05806 Version 5

## Product Update: Roof Molding

Supersedes 16-021, dated February 16, 2017 to revise the information highlighted in **yellow**

Year	Model	Trim	VIN Range
2016	Pilot	LX, EX, EX-L	Check the iN VIN status for eligibility

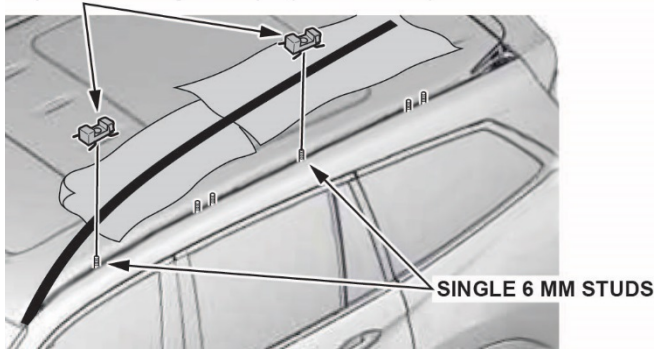
Replace existing M6 clips (natural color).

3. Install the two M6 clips (natural color) in the same location as the original clips (the single 6 mm studs).
4. Install the front M8 roof clip (yellow color) on the first stud of the double 8 mm stud as shown, then install the second M8 roof clip on the second double 8 mm stud.

**FORWARD DOUBLE STUDS**

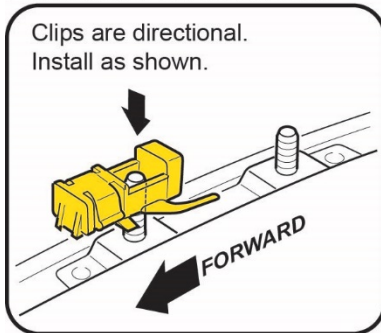
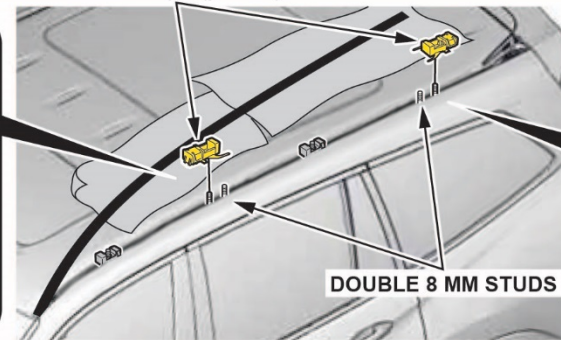
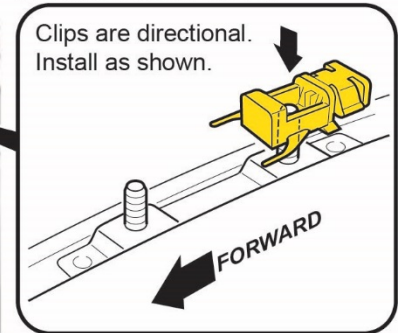
Add two M8 clips (yellow).
